#### AERONAUTICAL SURVEILLANCE PANEL (ASP) SURVEILLANCE SYSTEMS TECHNICAL SUBGROUP

## Proposed Change to Annex 10, Vol. IV for TIS-B Management Messages

This CP proposes an addition of Doc 9871 to define TIS-B/ADS-R management messages..

## **Proposed changes and Additions to Doc 9871**

Service Volume in the horizontal plane

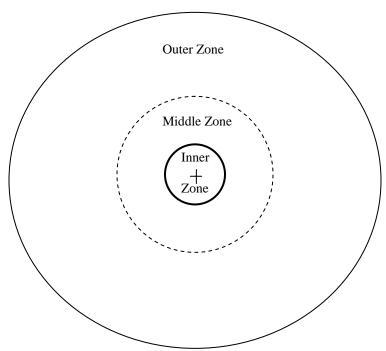
Note 3. The TIS-B/ADS-R Service Volume and Heartbeat Message permits the service volume to be described as the sum of 3 coverage zones (inner, middle and outer zones) with each zone defined as circular area and with a lower altitude floor. Also a altitude ceiling is provided that applies across the entire volume of airspace defined by boundary of the outer zone (i.e., also applies to the middle and inner zones). The use of three zones to depict the service volume is illustrated in the two figures below when viewed in the horizontal and in the vertical planes respectively.
